Memo

Re: Consultation on an Application

Planning Application Ref: PL/25/1173

Address: 40 Mount Pleasant, Reading, RG1 2TD

With reference to the Block Plan, Urban Grain, 3D views, Drawing No. 002, Rev P7 and the Landscaping & Bin Storage Elevations, July 2025, Drawing No. 03, Rev C, I note the following:

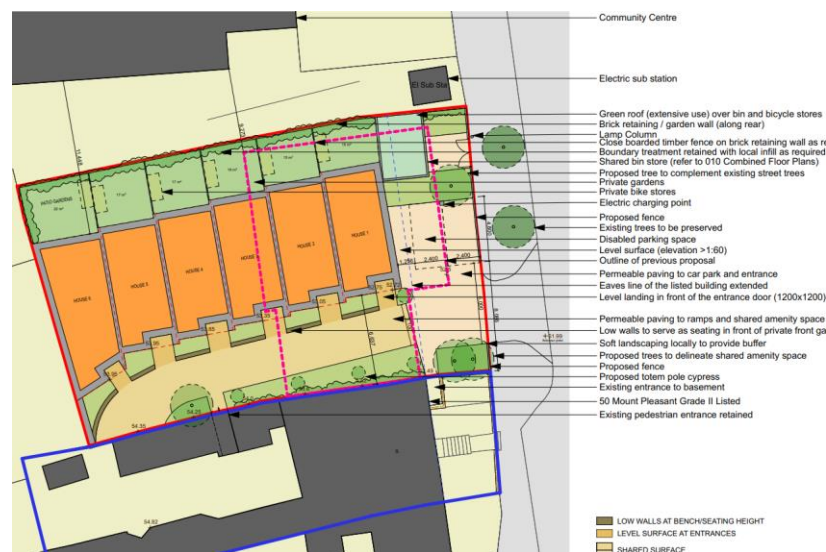
The previous landscaping offered to plant four trees within the site, three of which were adjacent to the road. This was a positive aspect of the previous application given the site is along a tree'd corridor, AQMA and within a low canopy cover ward. However, two trees adjacent to the road have been proposed to be relocated. Whilst their retention is positive, tree'd corridors should prioritise tree planting on the frontage/road side of developments.

In addition, all trees are now proposed in raised planters which is a significant concern in relation to 1) limiting their ultimate size as a result of limited soil volume provision 2) risk of root damage to planters (no specifications are provided) and 3) a greater need for irrigation. No detail has been provided to demonstrate how proposed tree planting can be successful in the long-term.

The plans show only 2 parking spaces; one adjacent to an EV charging point. I note the 'Planning Design & Access Statement including Heritage Statement' refers multiple times to the disabled parking space – it is not clear from the plan which this is. In any case, if only two parking spaces are required, it is unclear why more of the southern boundary can't be afforded to soft landscaping, instead of tree planting being confined to small planters – clarity is required.

The rear gardens of the previous application incorporated the existing northern boundary vegetation. The proposed landscaping plans do not indicate this being included which is negative as it appears there will be a loss of vegetation – it is unclear what is proposed within the rear gardens hence clarity is required.

I also note a reduced amount of soft landscaping through out the entire site. The previous plans included plots of green communal spaces where as the proposed plans offer a lesser amount of communal green spaces whilst including more hard surfacing.
